Technical Bulletin

Number 191

February 16, 2010

Direct Spark Ignition Module Wire Conversion Chart

New Idler

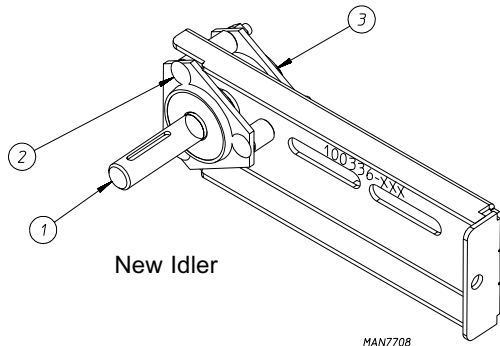
Main Line Idler Change

The following idler assemblies have been changed: 882576, 882776, 882777, 882778, 883473.

The new idler has some improvements compared to the old.

1. Thicker shaft, more durable and heavy duty.
2. Bigger bearings to support the thicker shaft.
3. Larger and thicker gauge bearing plates.

IMPORTANT
The parts between these two idlers are **NOT** interchangeable.

Conversion from 128928 and 140026 to Current Production Gas Valve Instructions

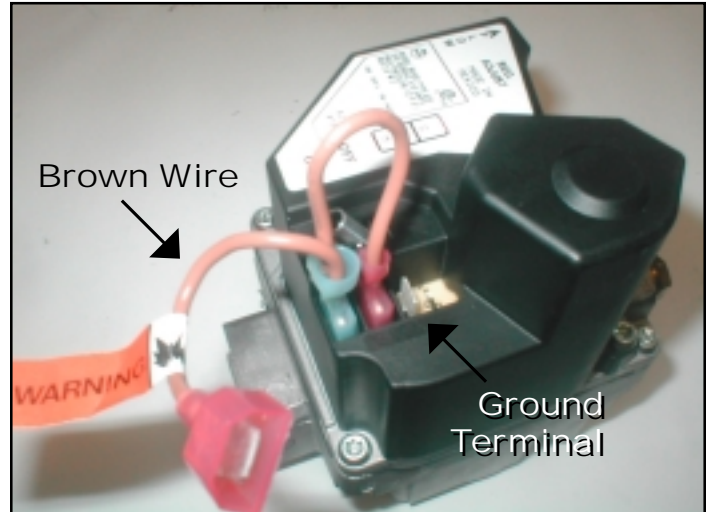
The "36C" type gas valves used in ADC past and current mid-production line have been discontinued by the vendor and replaced by a "36H" type gas valve. The previous type valve can be replaced by the current "H" valve. However, some modifications may be required.

The current "H" valve P/N 128099 when sold as a parts order is kit number
 NATURAL GAS 887159
 L.P. GAS 887155

1. Make terminations on the gas valve as shown in photograph.
2. Phase 6 and 7 computer models: need to connect the yellow "Y" terminal provided to the brown wire as shown in the photograph. Then using the "Y" terminal, connect MV from the module and the orange and silver wire that connects to the computer board to the brown wire.
3. Last, connect the ground wire to the open terminal on the gas valve.

Important: The L.P. kits for the 36C and 36H valves are totally different and not interchangeable!
